**Florida  
Power**  
CORPORATION

Subject: Crystal River Unit 3  
Docket No. 50-302  
Operating License No. DPR-72  
Nuclear Safety Task Force Priority Items and  
Confirmatory Order for Crystal River Unit 3, dated  
April 14, 1980

Enclosure B of this submittal gives the fifty-one (51) Priority Items of the Nuclear Safety Task Force and their responses.

TYPICAL  
VITAL  
PARAMETER

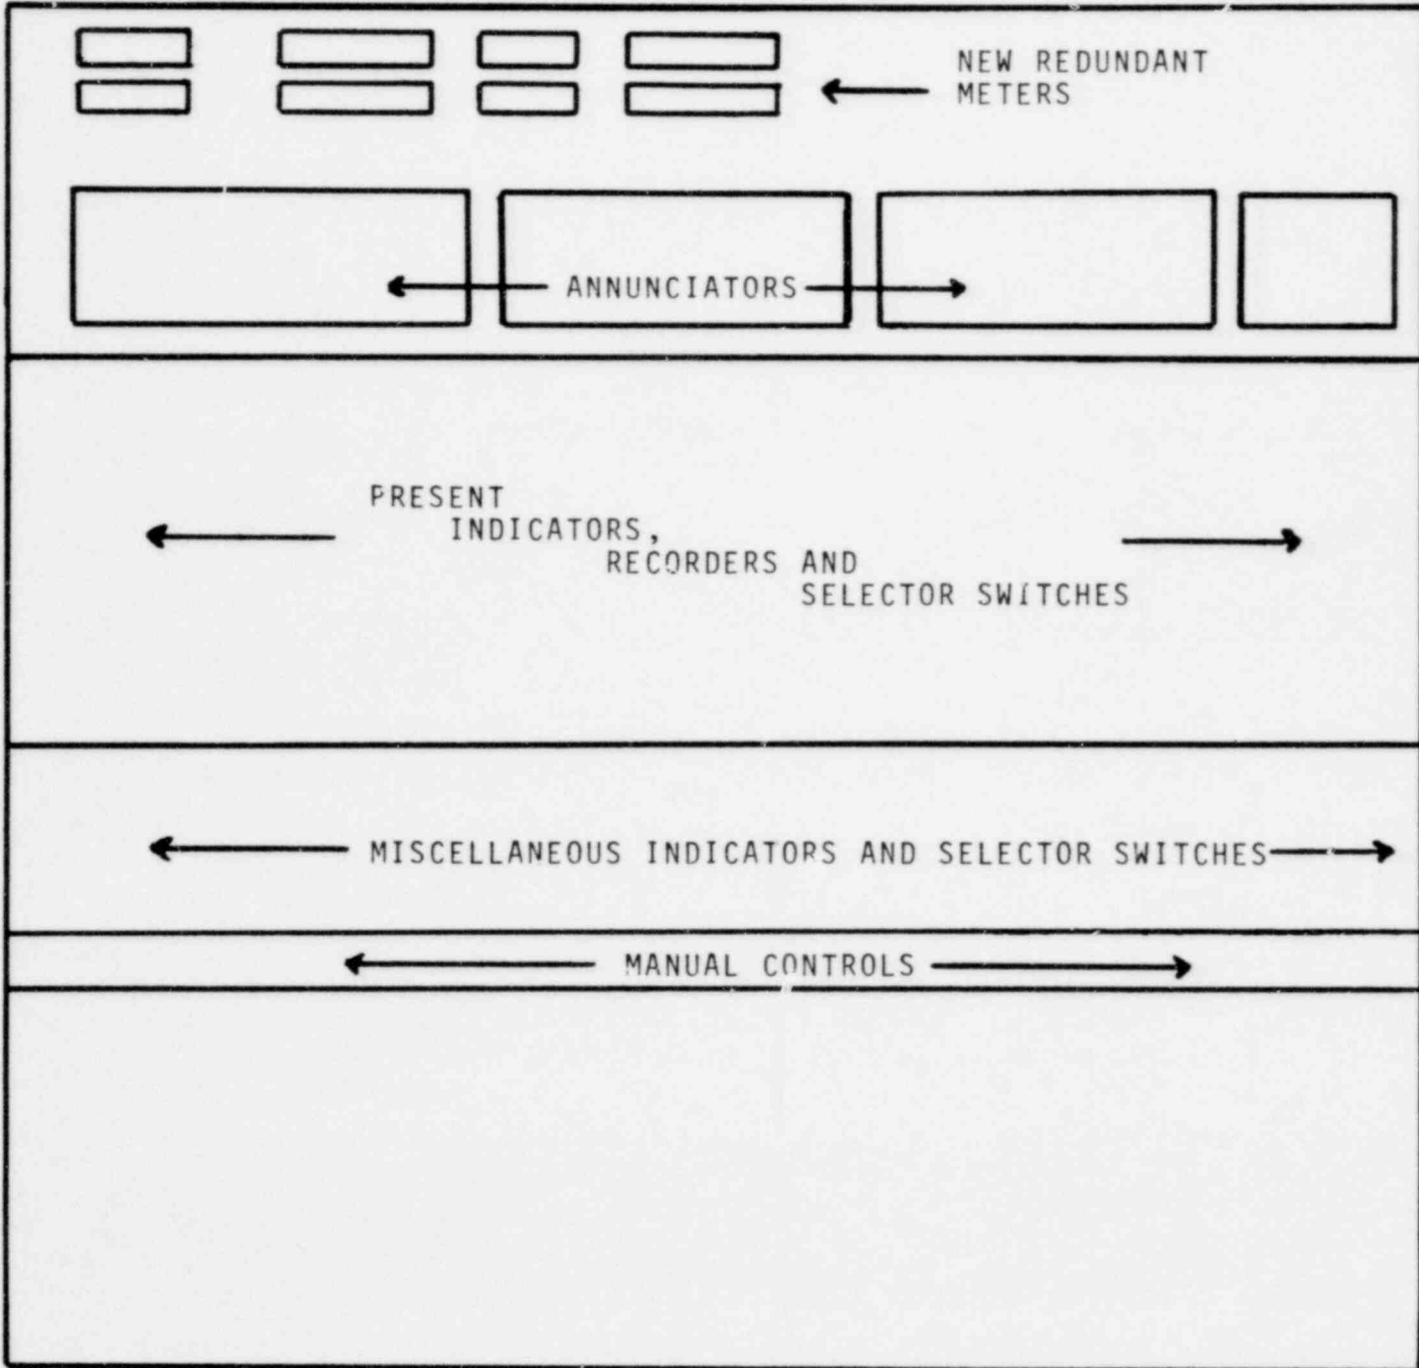
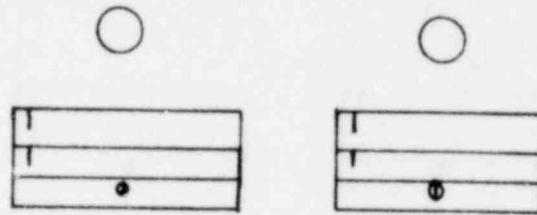
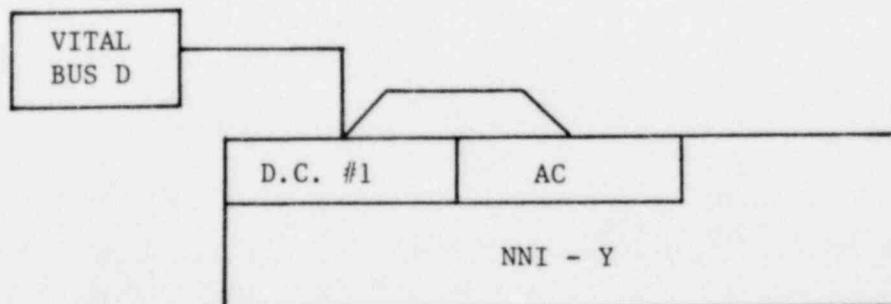
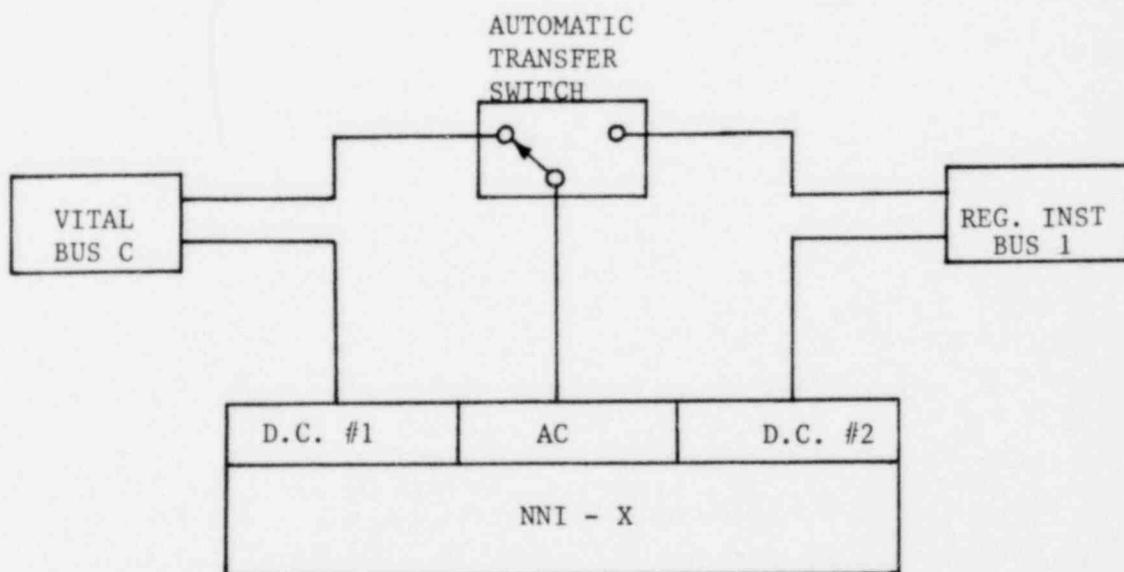
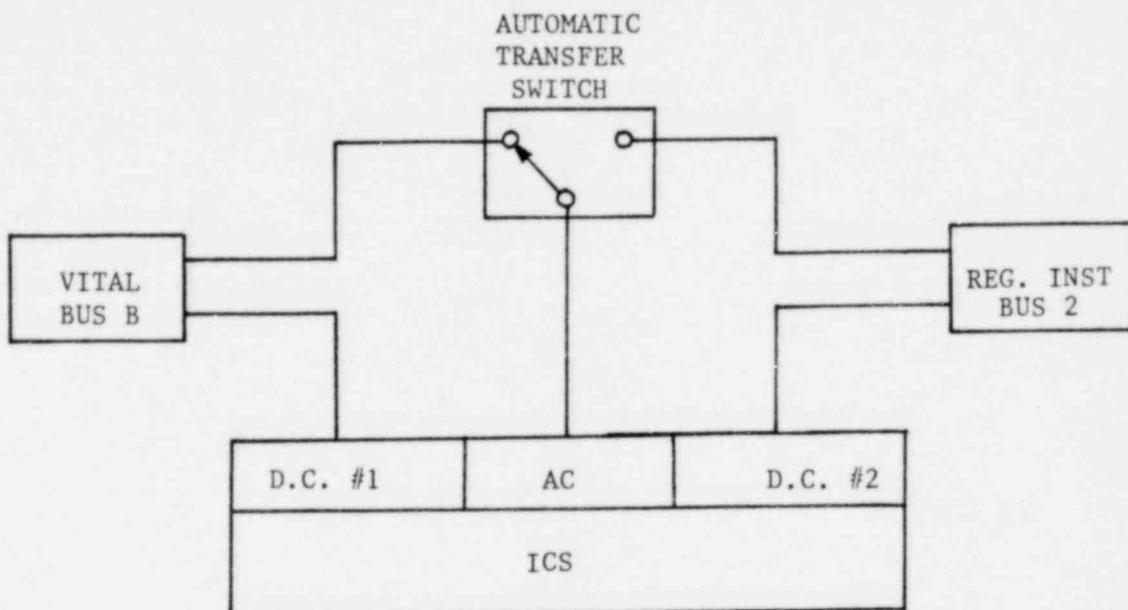
Provide operator with redundant indications of main plant parameters.

The main plant parameter NNI system instrumentation consists of signals originated at 120 VAC-powered transmitters, signal conditioning by 24 VDC-powered electronic modules, and display by 120 VAC-powered indicators or recorders. NNI(X) and NNI(Y) supply all three types of power. The signal conditioning modules were mixed in instances between NNI(X) and NNI(Y). These vital instrument loops will be revised to achieve separation from the transmitter through conditioning to new indicators. These new indicators are self-powered and require no 120 VAC for operation and are an addition to existing main control board (MCB) indicators.
